09117
10 November 2011

**SECTION 75W MODIFICATION - MP09_0154 (MOD 1)
7 RAILWAY STREET, CHATSWOOD**

On behalf of Mirvac Projects Pty Ltd we hereby submit an application pursuant to section 75W of the *Environmental Planning and Assessment Act, 1979* (EP&A Act) to modify Project Approval MP09_0154 relating to 7 Railway Street, Chatswood.

Figure 2 – Approved wind mitigation strategy
Source: Windtech Pty Ltd

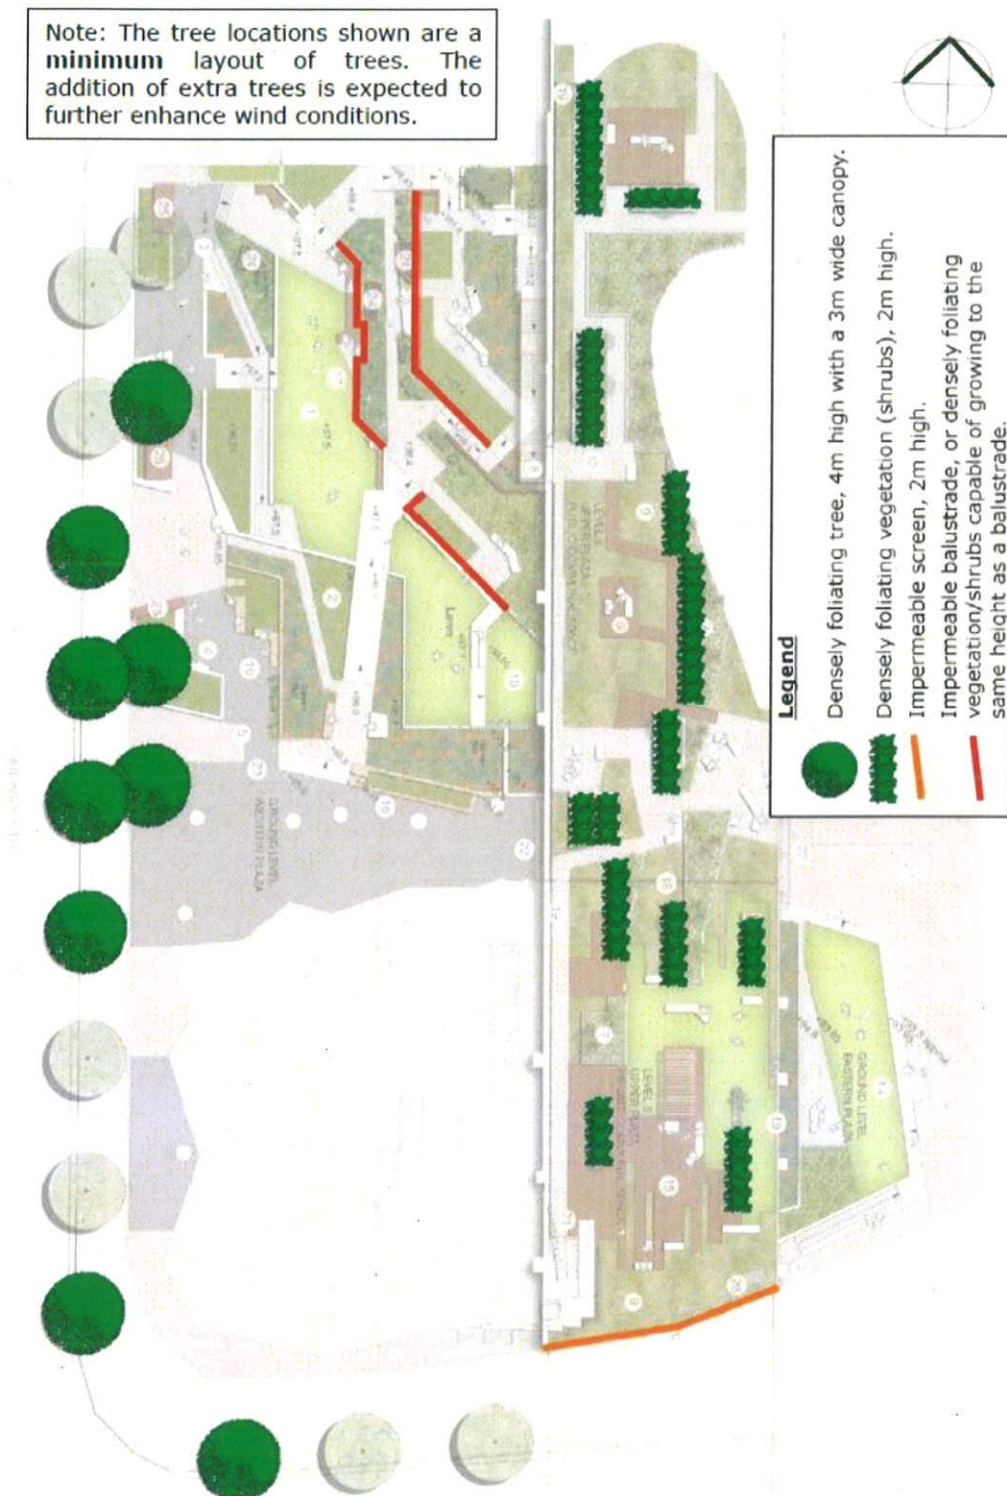
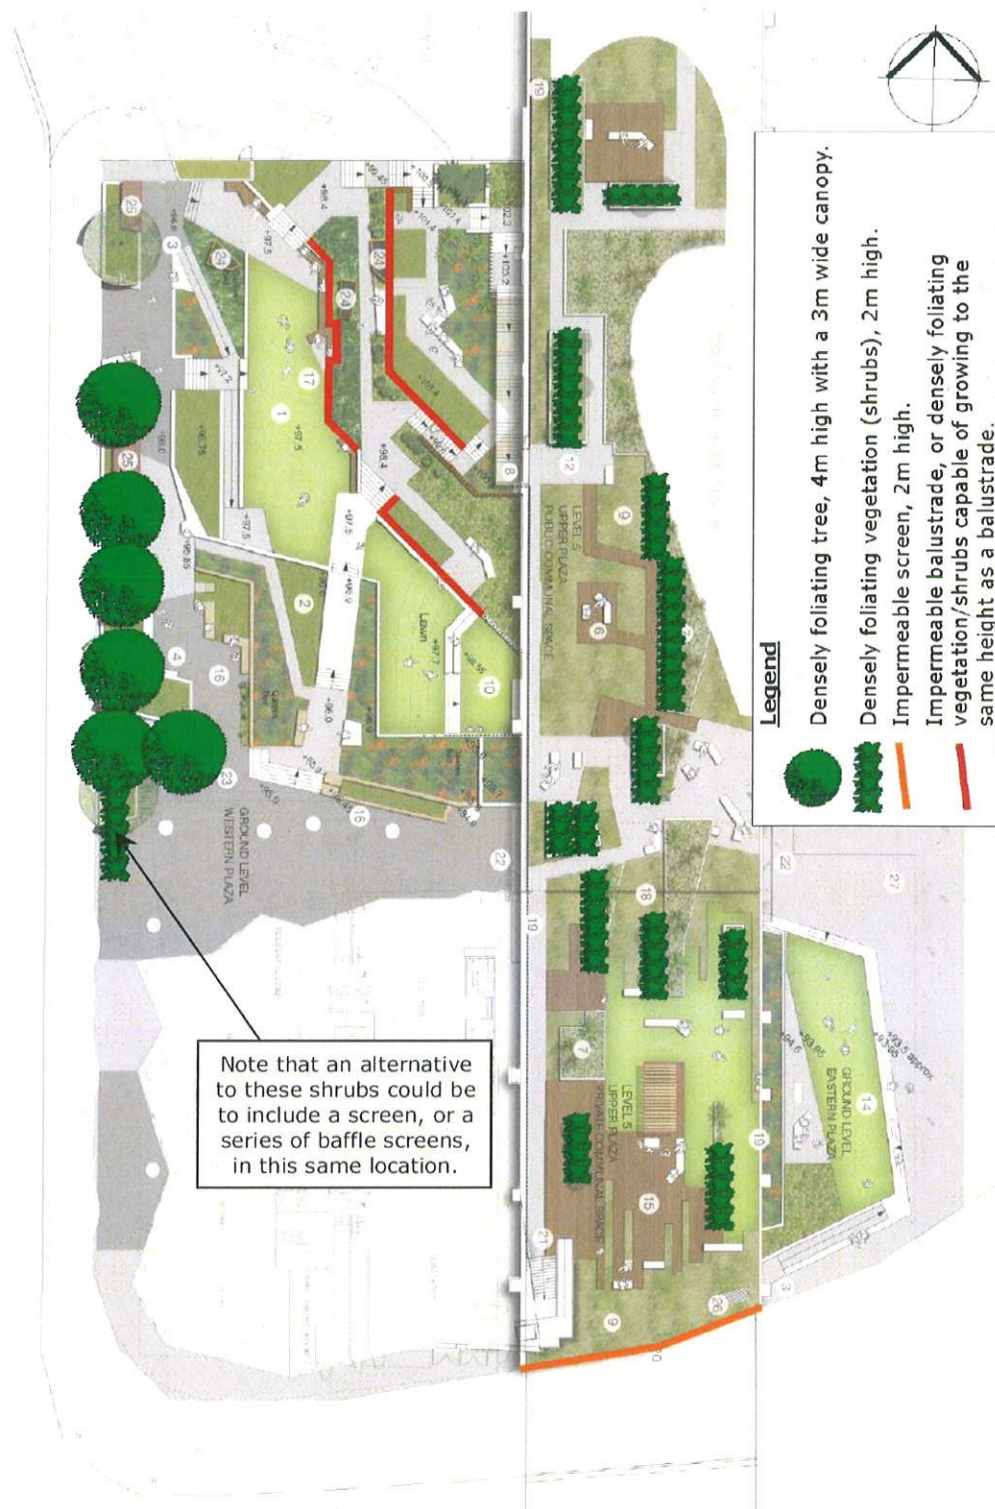
As a result of not being able to plant trees within the footpath on Railway Street due to the location of major services located within the footpath, Windtech Consultants Pty Ltd was commissioned to provide an alternative wind mitigation strategy.

The approved and revised wind mitigation strategies are shown in **Figures 2 and 3** respectively (see **Attachment F**).

Windtech Pty Ltd is of the opinion that the revised wind mitigation strategy will result in an acceptable wind environment. Specifically the assessment found that:

- All ground level pedestrian footpaths would meet the comfortable walking criteria of 7.5m/s for the weekly maximum GEM wind speed subject to the installation as ;
- The through site link would also meet the above criteria subject to the installation of 2m high shrub/hedge as shown in **Figure 3**; and
- That the northern landscaped garden would also provide a suitable level of amenity for intended users.
